SITE SUPPLEMENTAL INSTRUCTION

PROJECT: Forestside Estates
Attmar & Palleschi Drive
Brampton, ON

SITE SI NO. M-1

PURPOSE: To revise mechanical layout to suit architectural CS drawing and City comments for P1 level.

TITLE
BLOCK 'B'
4TH FLOOR - PLUMBING/SANITARY

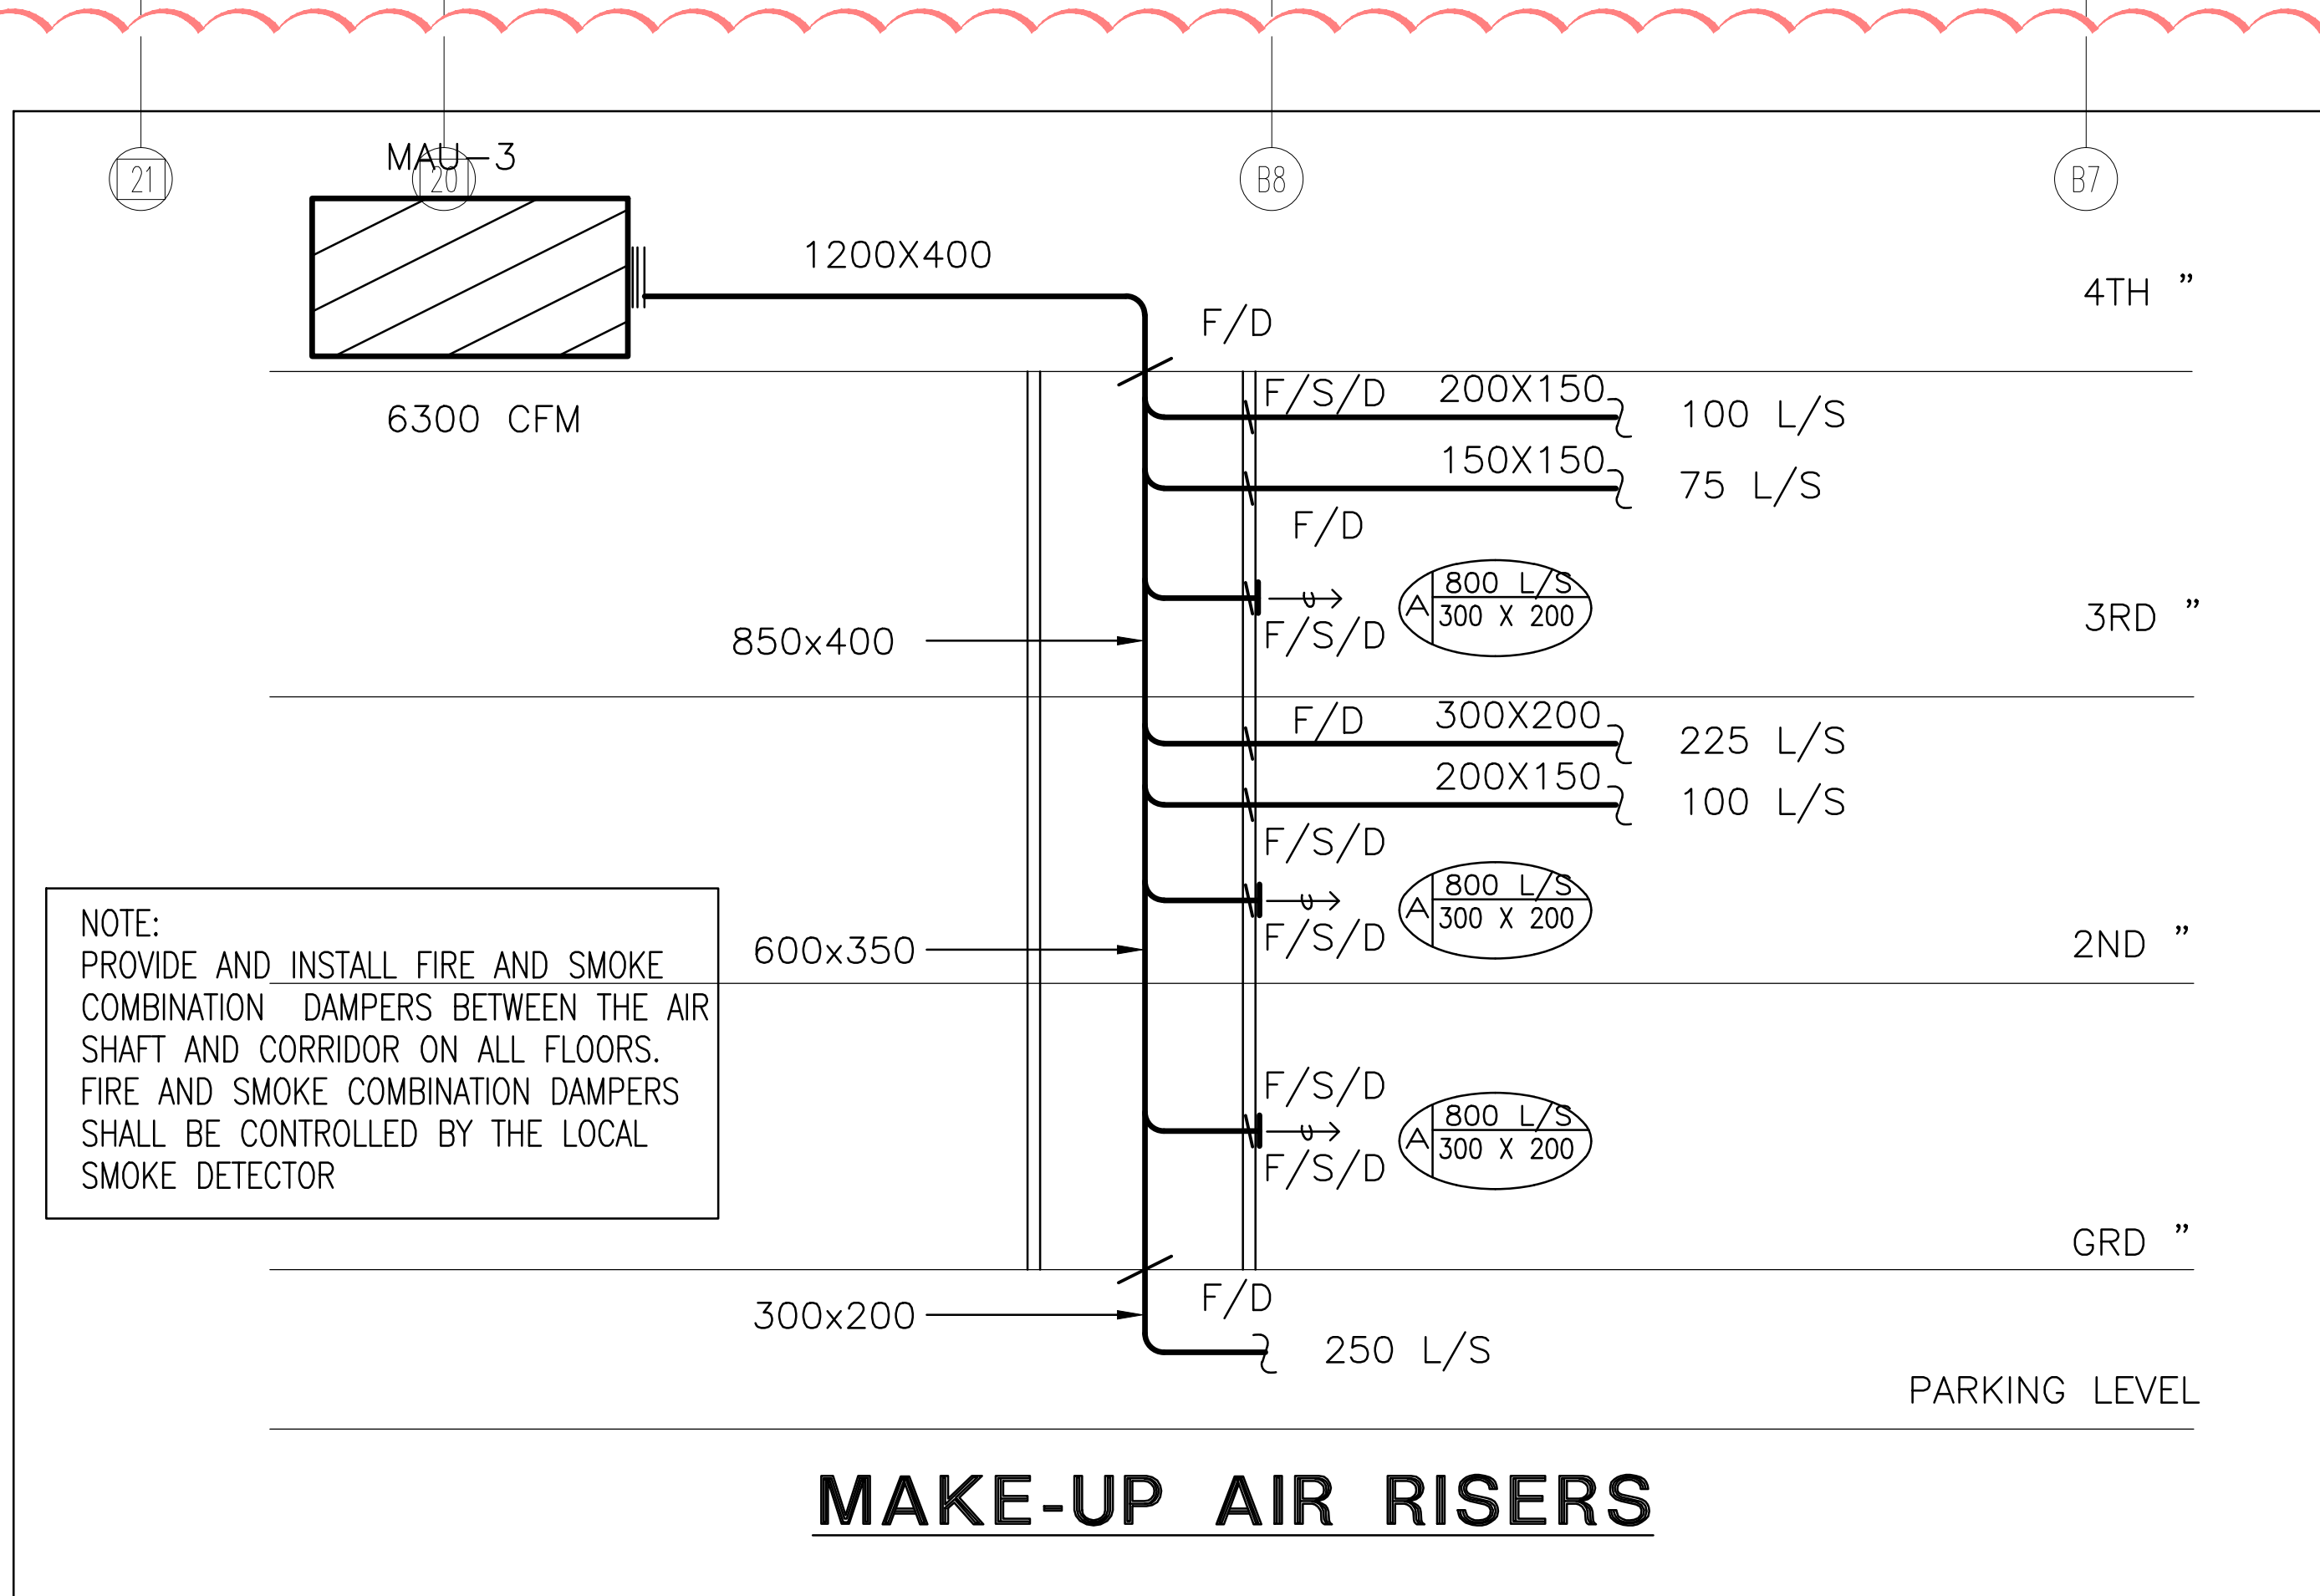
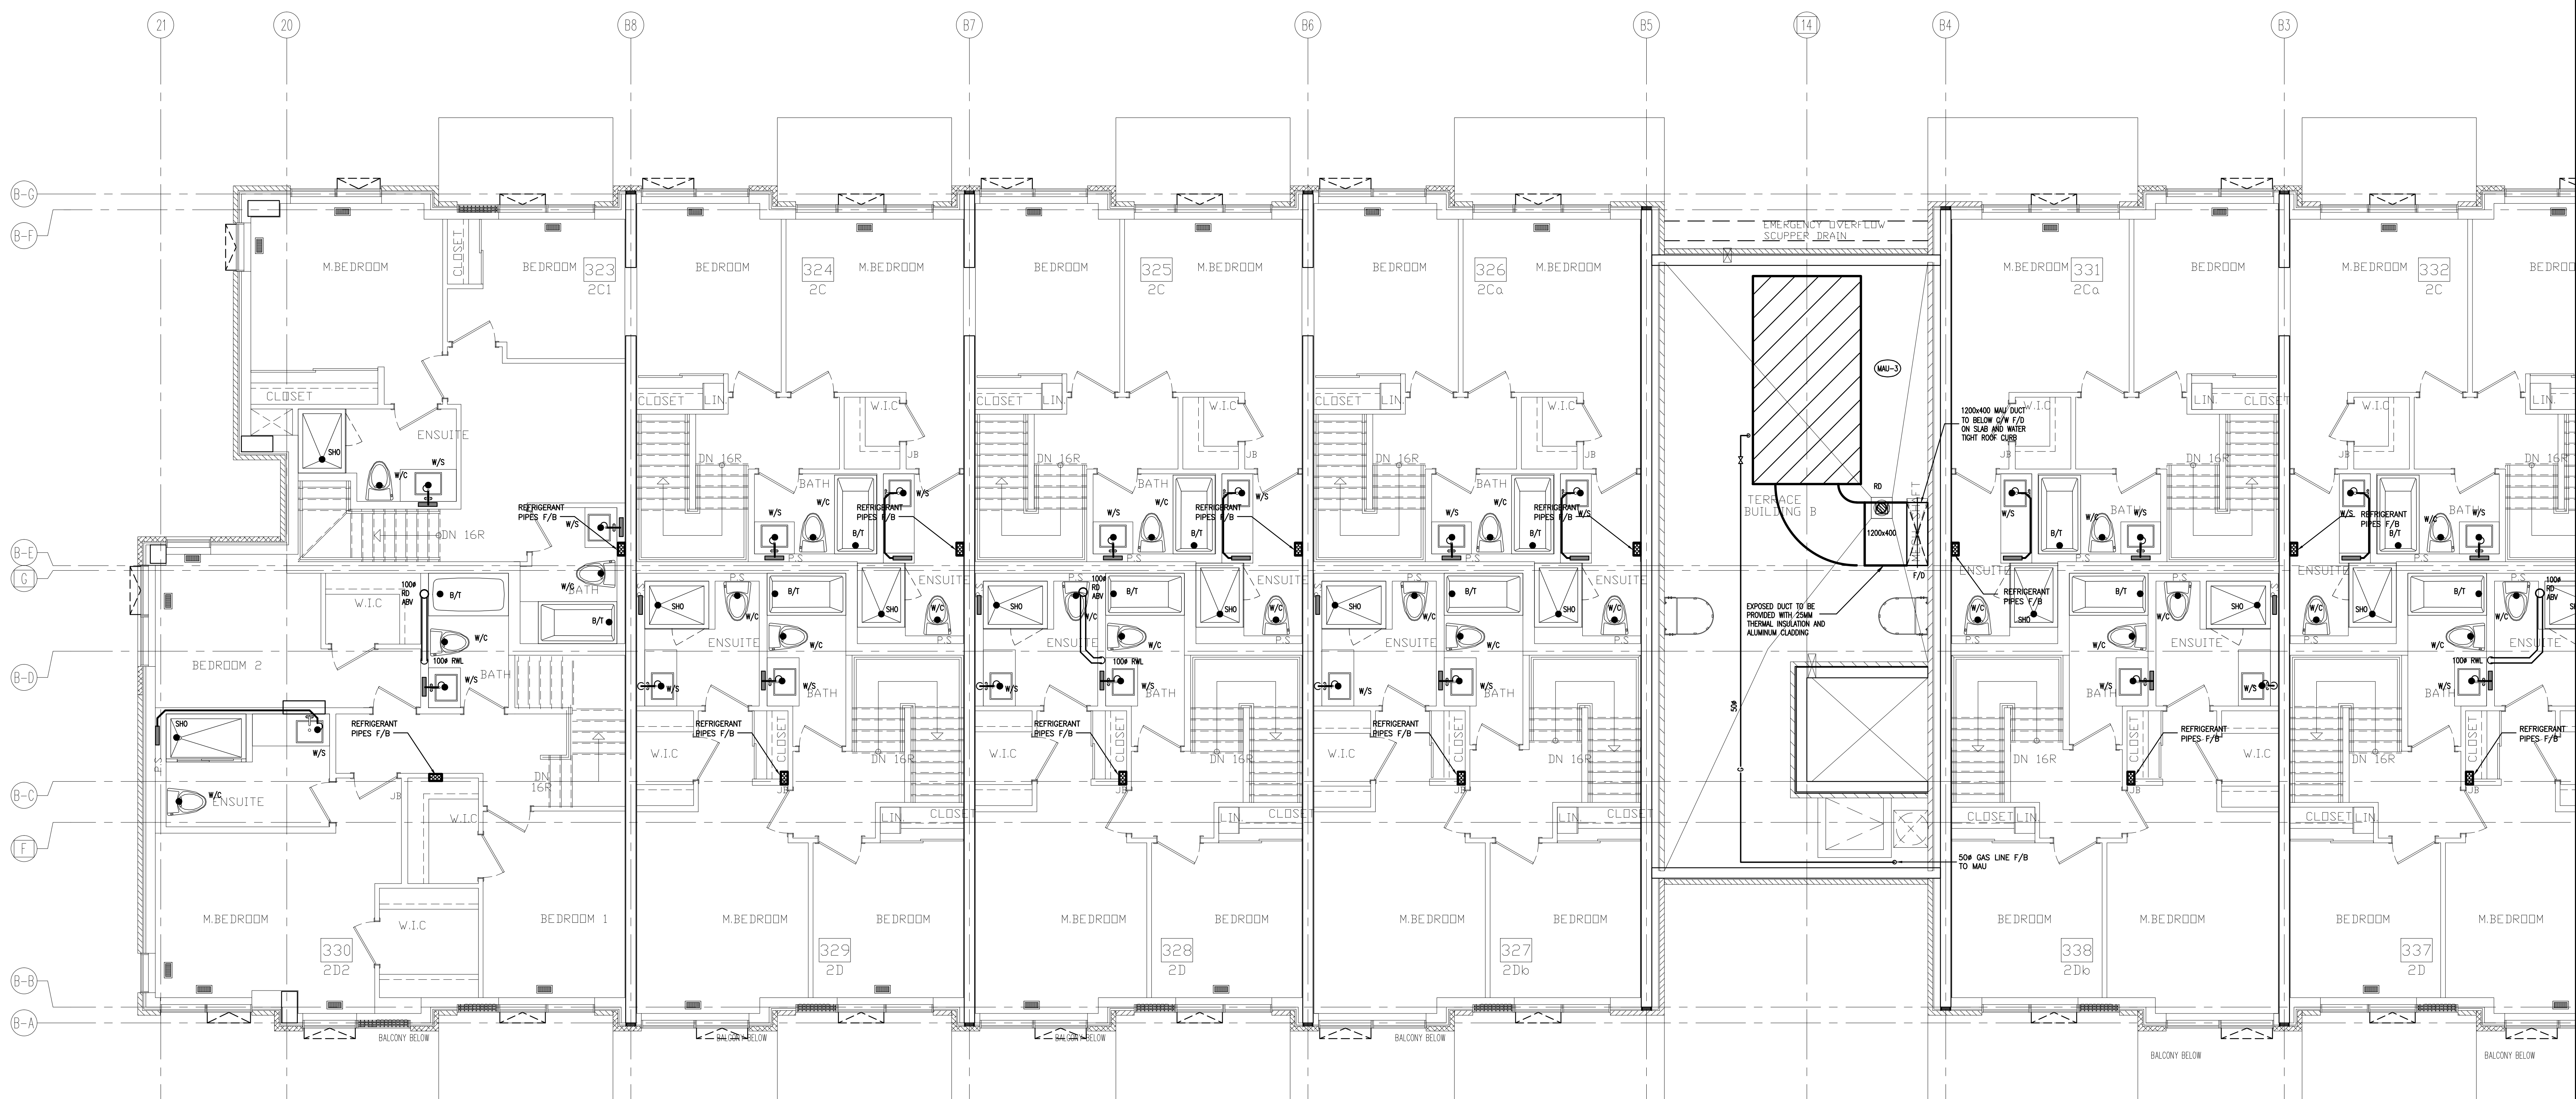
7.0 Reference Drawing M-31 (Blk “B” 4th1 - Mechanical) Issued

7.1 Revise: Mechanical make-up air riser.

7.2 Added: Combined fire and smoke damper for all the opening to public corridor.
